# HERBATA DATA CENTRE, NAAS - RESPONSE TO REQUEST FOR FURTHER INFORMATION ("RESPONSE TO RFI") FROM KILDARE COUNTY COUNCIL

## ADDENDUM TO CHAPTER 4 DESCRIPTION OF THE PROJECT AND NEED FOR THE PROJECT

NI2615  
01  
June 2025

Figure 4.2: Amended Overall Proposed Site Plan (extract of now submitted drawing 22217-RKD-ZZ-ZZ-DR-A-1010-OVERALL PROPOSED SITE PLAN)

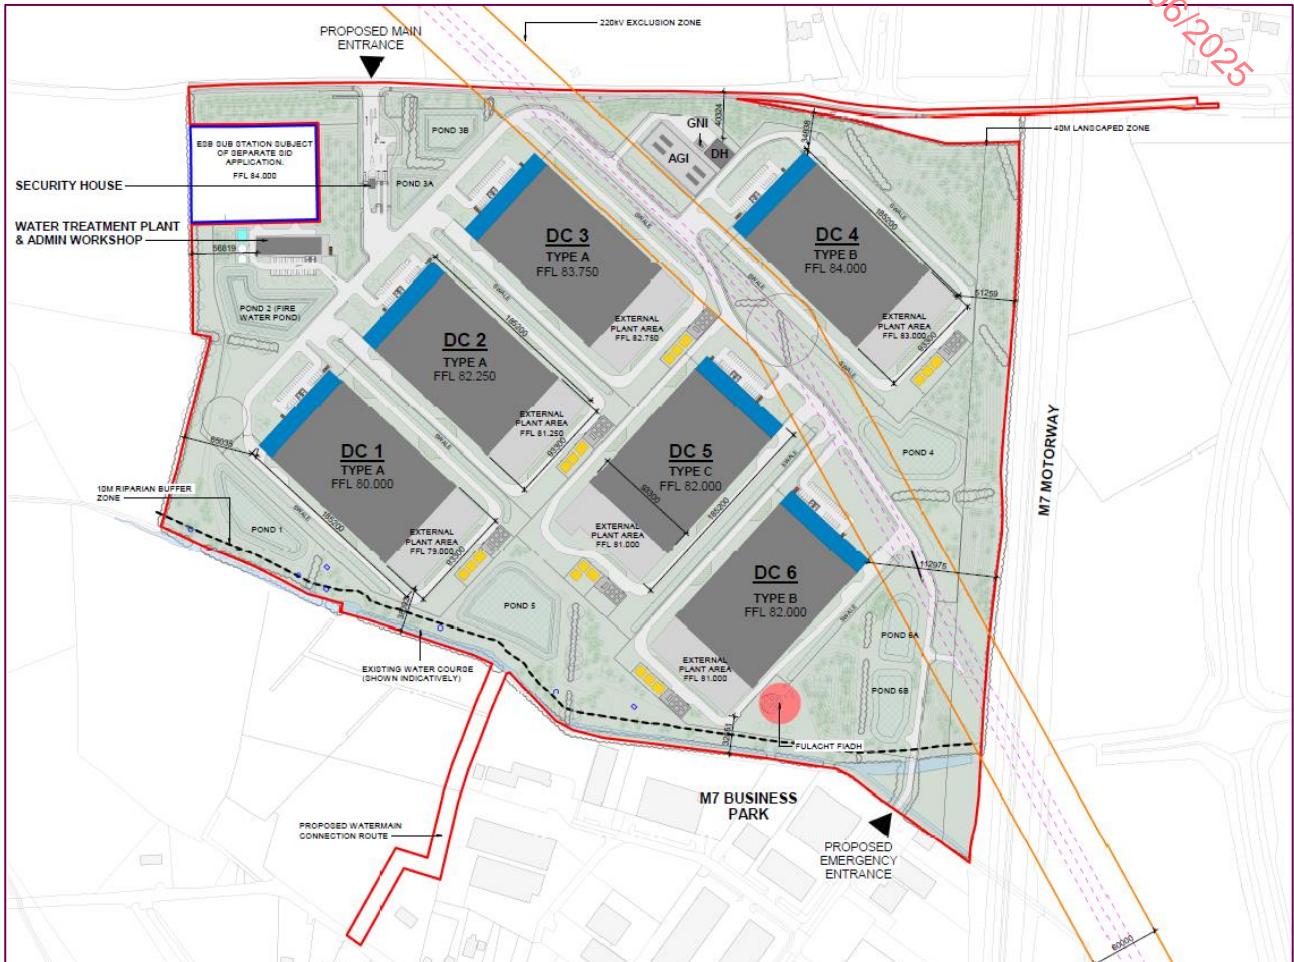
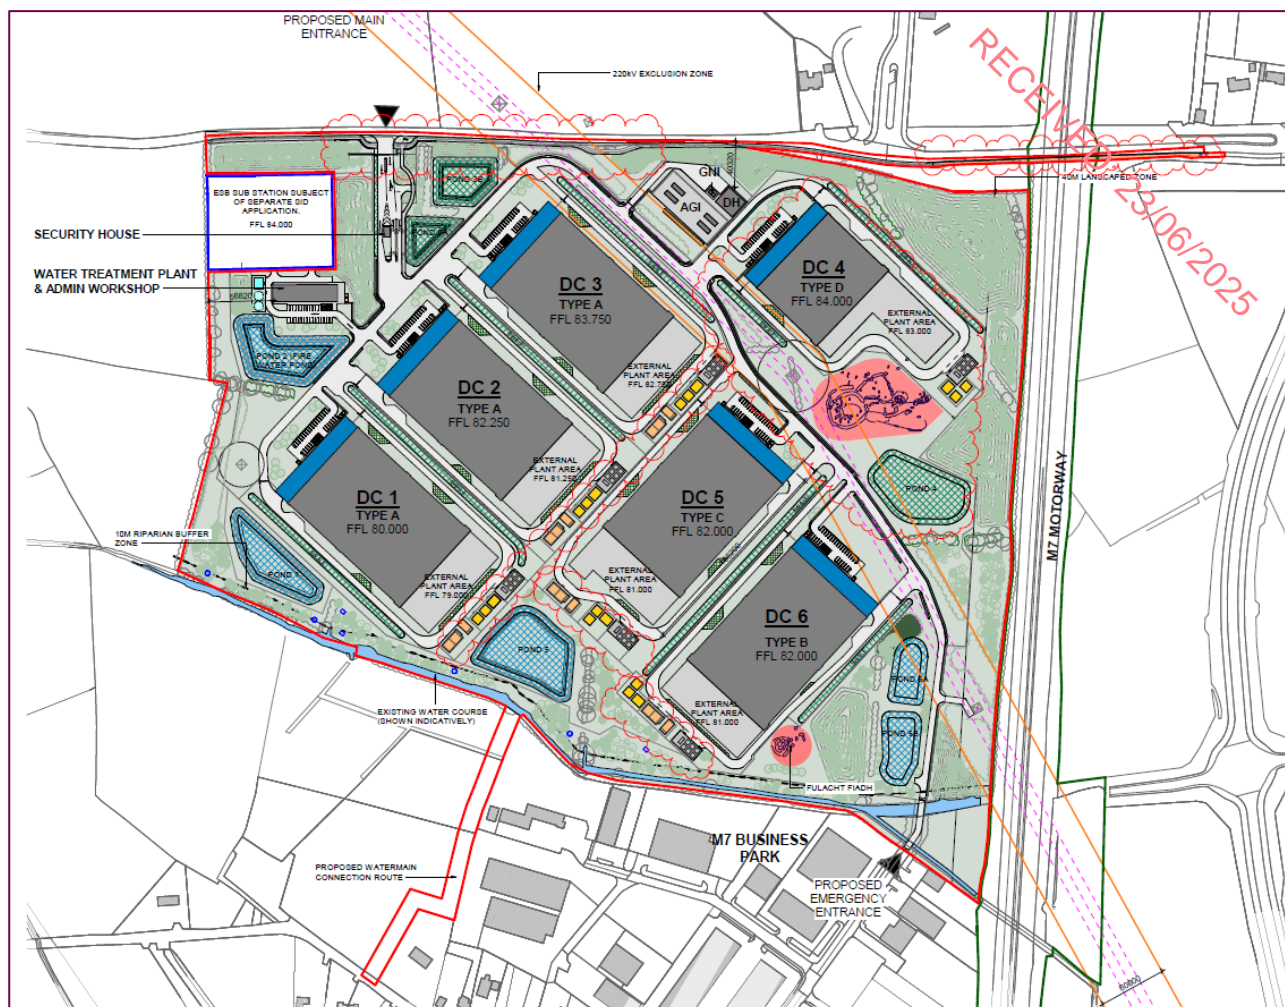
For the purpose of comparison, Figures 4.1 and 4.2 below, illustrate the previously submitted *Overall Proposed Site Plan* and (amended) proposed site context plan, respectively.

Figure 4.4: Amended Proposed Site Plan (extract of now submitted drawing 22217-RKD-ZZ-ZZ-DR-A-1012-PROPOSED SITE PLAN B)

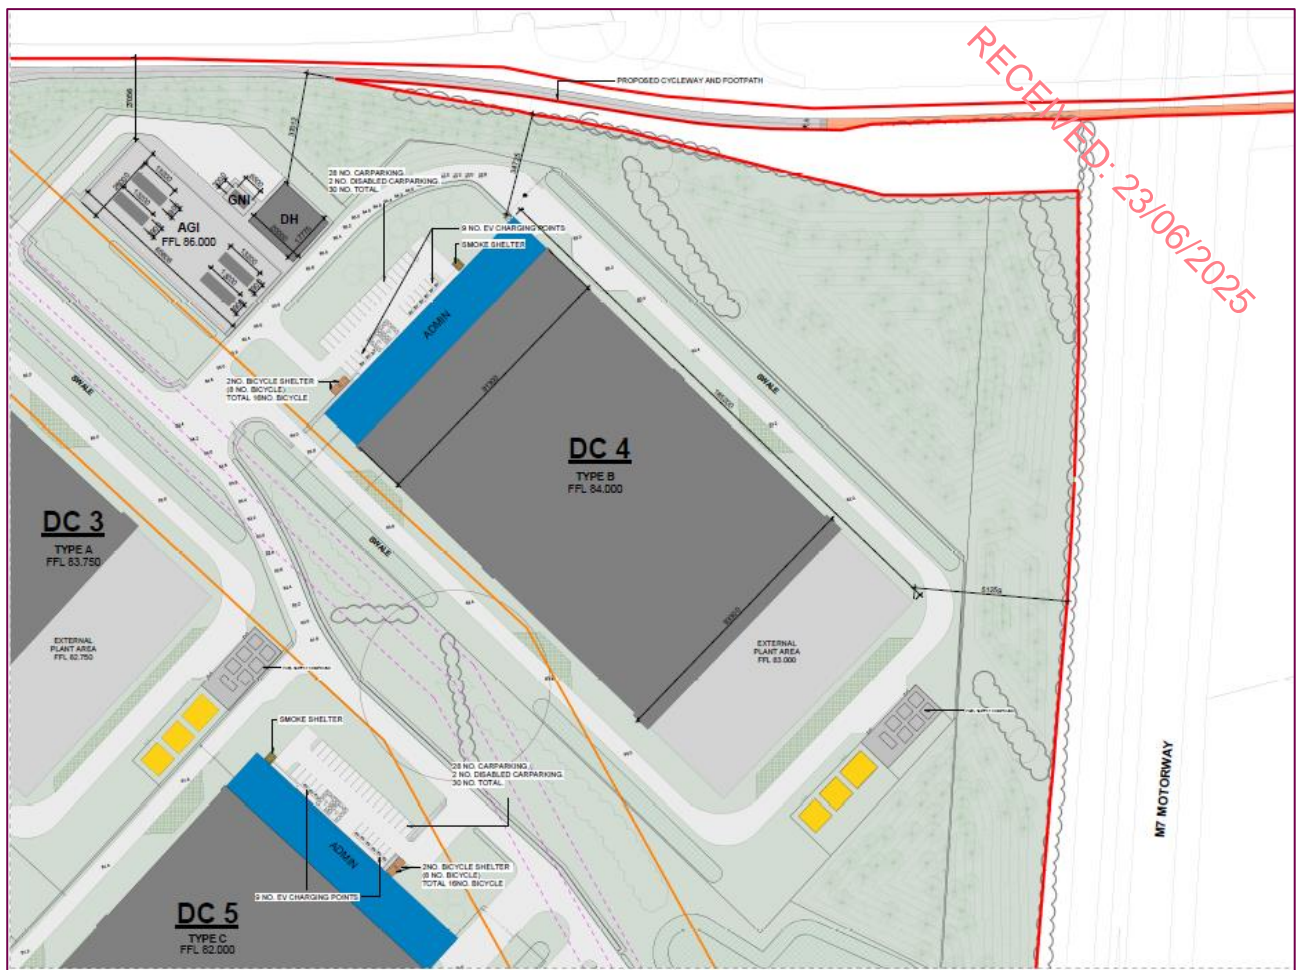
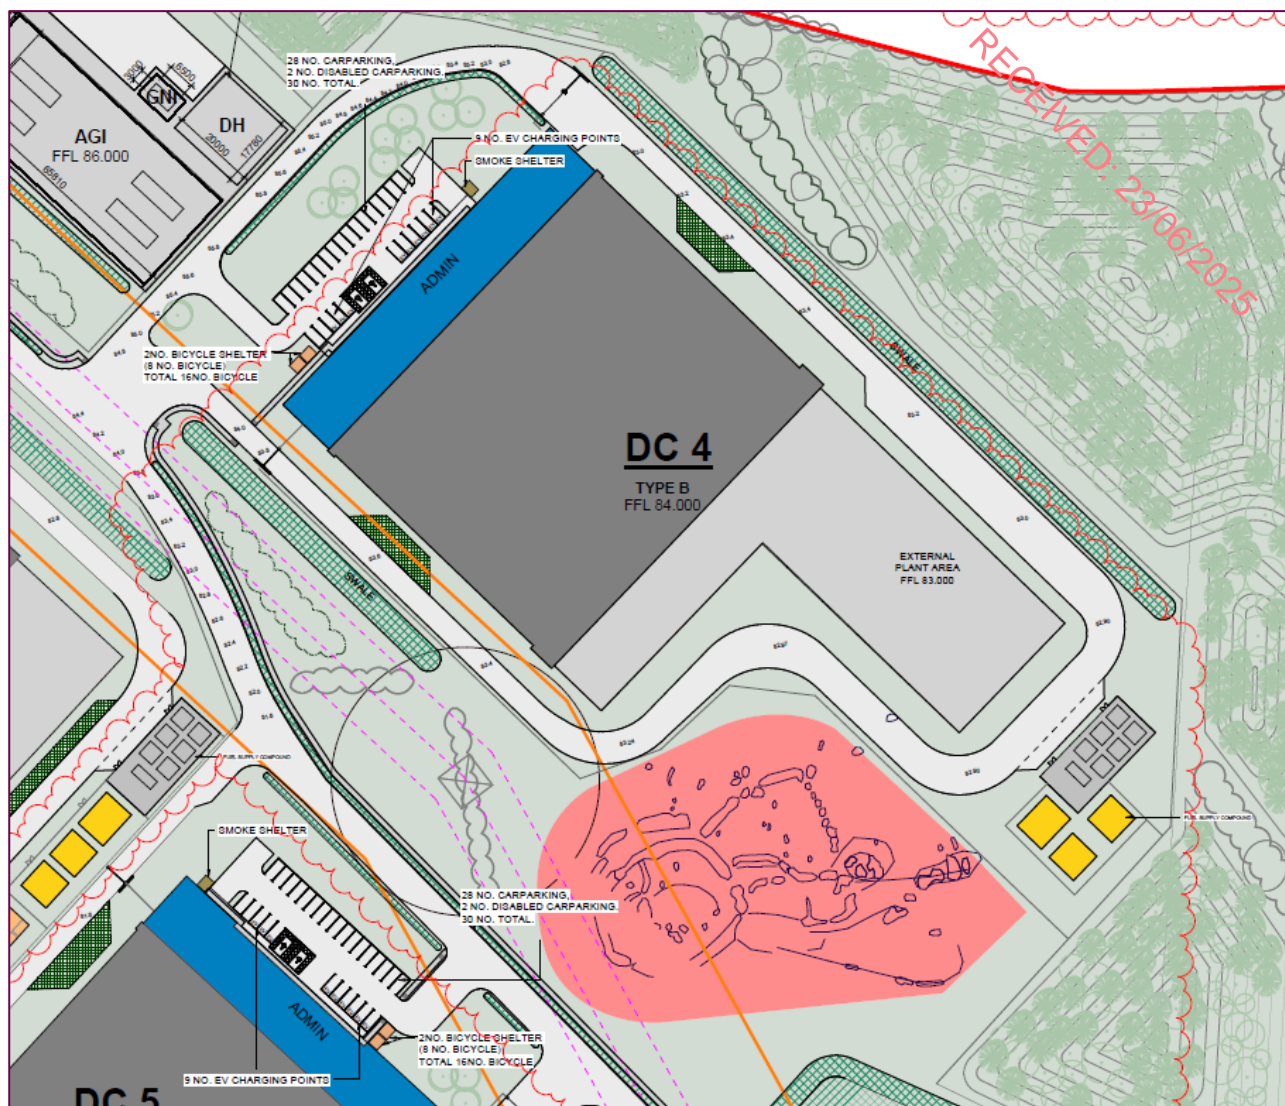
The amended design for Data Centre 4 is primarily in respect of the external plant yard (to the rear of the building) and subsequently, the overall shape of the building and an overall reduction in the area of the building.

Data Centre 4 retains the *templated design*, common to Data Centres 1 – 3, 5 and 6 but with a reduced gross internal area (GIA), reflective of the amended shape of the building, as noted below:

- Total Area – 16,188m<sup>2</sup> (previously 27,261m<sup>2</sup>)
- Height to parapet – 18m – unchanged
- Height to flue – 19m – unchanged
- Building height - c.19m – unchanged

Figure 4.6: Amended Solar PV Arrays, Data Centre 4 (extract of now submitted drawing 10360452-HDR-ZZ-02-DR-E-602003)

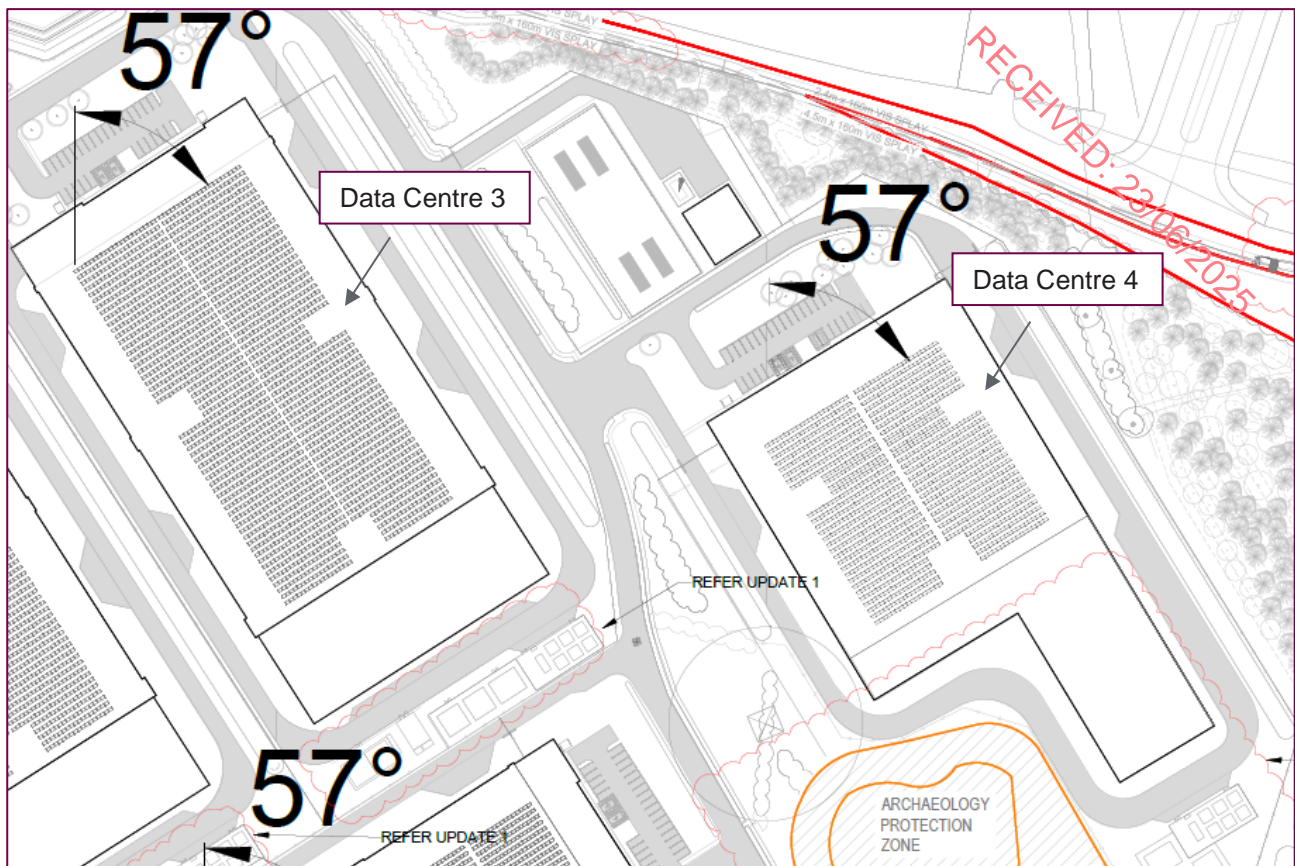
Data Centre 4 will maintain the proposed solar photovoltaic (PV) arrays, located on the roof top albeit with a reduction in the number of panels, due to the amended design of the building. The amended design of Data Centre 4 comprises solar PV arrays with an area of 1800m<sup>2</sup> whilst the remaining data centres retain the submitted area of solar PV of 3600m<sup>2</sup>. Figure 4.6 below illustrates the arrangement of solar PV panels on Data Centre 4 due to the amended design in comparison to the arrangement of solar PV panels on the adjacent, Data Centre 3.

Figure 4.7: Proposed Air Cool Condensers and Steam Turbine (extract of now submitted drawing 10360452-HDR-XX-XX-DR-C-082111)

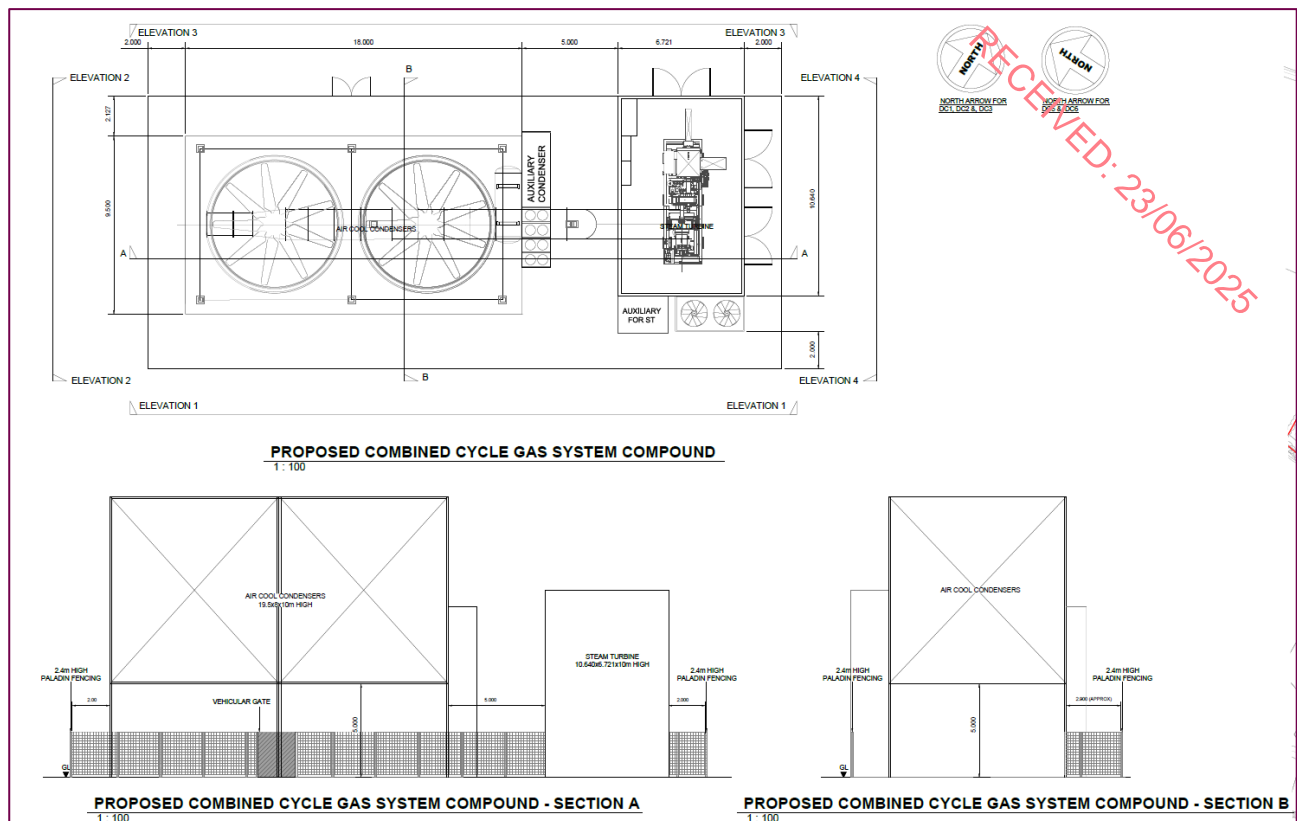
Due to the amendment to the Project Energy Strategy (as detailed further in Section 4.2.3) and specifically in respect of the proposed Combined Cycle Gas Turbines (CCGTs), amendments have been made by way of additional compounds to the rear of each Data Centres 1 - 3, 5 and 6. The amendments include the provision of air cool condensers and a steam turbine, adjacent to the fuel supply and sprinkler supply compounds (as proposed in the submitted planning application). Figure 4.7 below illustrates the layout and an elevation of the condensers and steam turbines.

Figure 4.8: Detail of Proposed R409 Improvements (extract of now submitted drawing 2232-DOB-ZZ-ZZ-DR-C-1600)

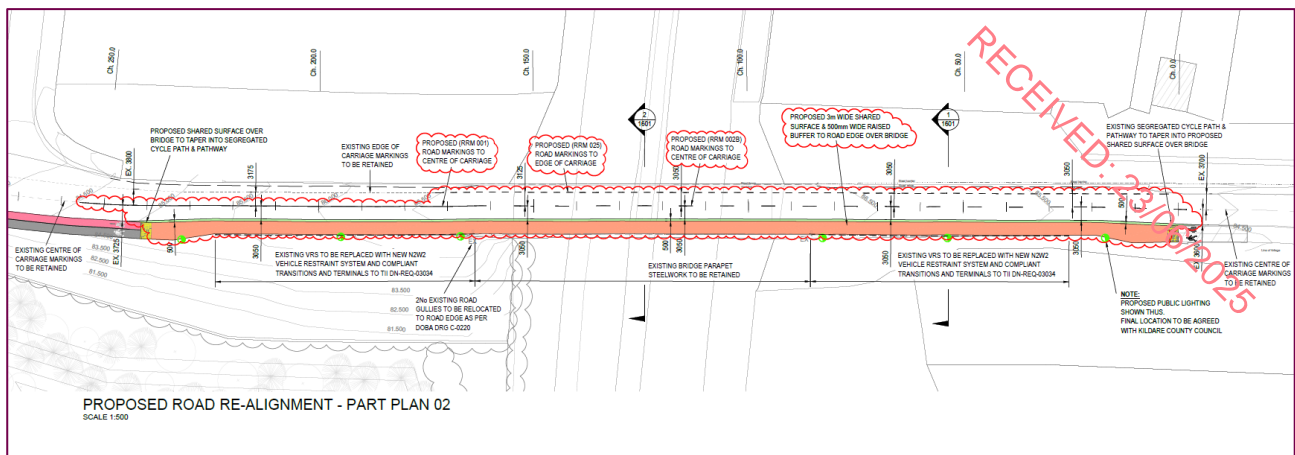
Amendments are proposed in respect of the Kildare County Council Roads Department for a footpath and cycle path as part of the proposals, along the R409 Caragh Road, which traverses the M7 motorway on an overbridge. The amendments to provide a footpath and associated line markings and replacement of the traffic barriers will be undertaken on the R409 (where it traverses the M7 motorway) are detailed in the now submitted drawing 2232-DOB-ZZ-ZZ-DR-C-1600 PROPOSED R409 ROAD VRU IMPROVEMENTS.

The proposed amendments comprise of the provision of a 3m shared surface (with a 500mm buffer) across the bridge and a reduction in the carriageway width from 7.8m to 6.1m, across the bridge; by comparison, the submitted application proposed a 2m shared surface (with no buffer).

Figure 4.9: Landscape Proposals Relative to Amended Design of Data Centre 4 (extract of now submitted drawing BSM-ZZ-ZZ-DR-L-0301)

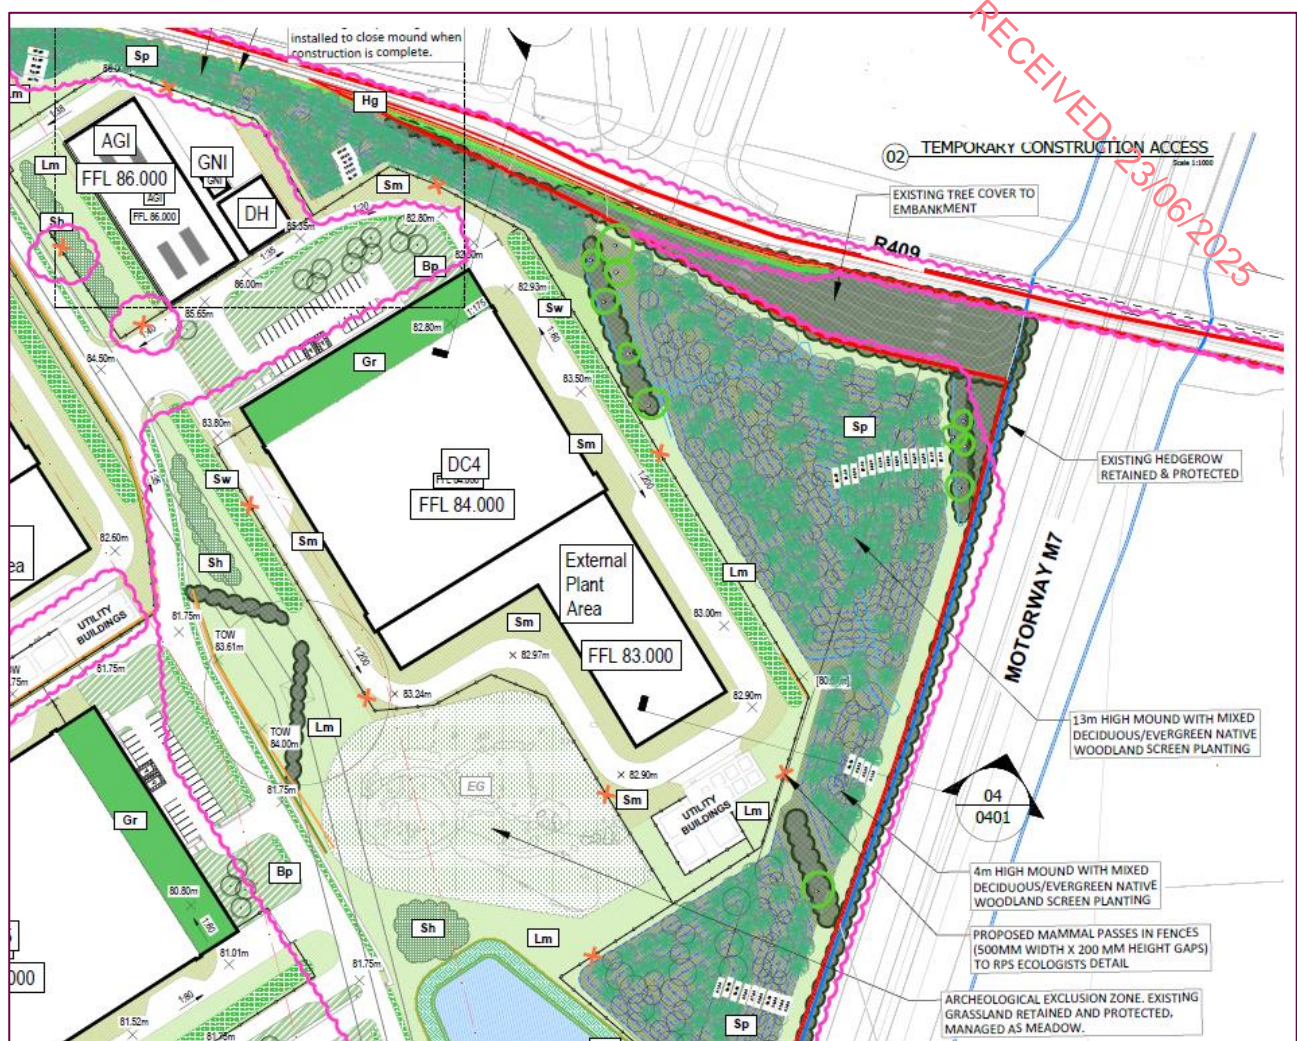
The amended design for Data Centre 4 has resulted in some minor amendments to landscape proposals within the immediate vicinity of the building; these however are minor in nature and do not alter the proposals as submitted in respect of retention of existing vegetation, proposed mounding and landscape planting along the site boundaries.

There have been a number of other minor amendments within wider the site, which have been updated in the landscape design drawings; these relatively minor amendments do not however significantly change the landscape proposals along the site boundaries. Figure 4.9 (extract from landscape masterplan, drawing number BSM-ZZ-ZZ-DR-L-0301) below illustrates the landscape proposals, relative to amended design of Data Centre 4.
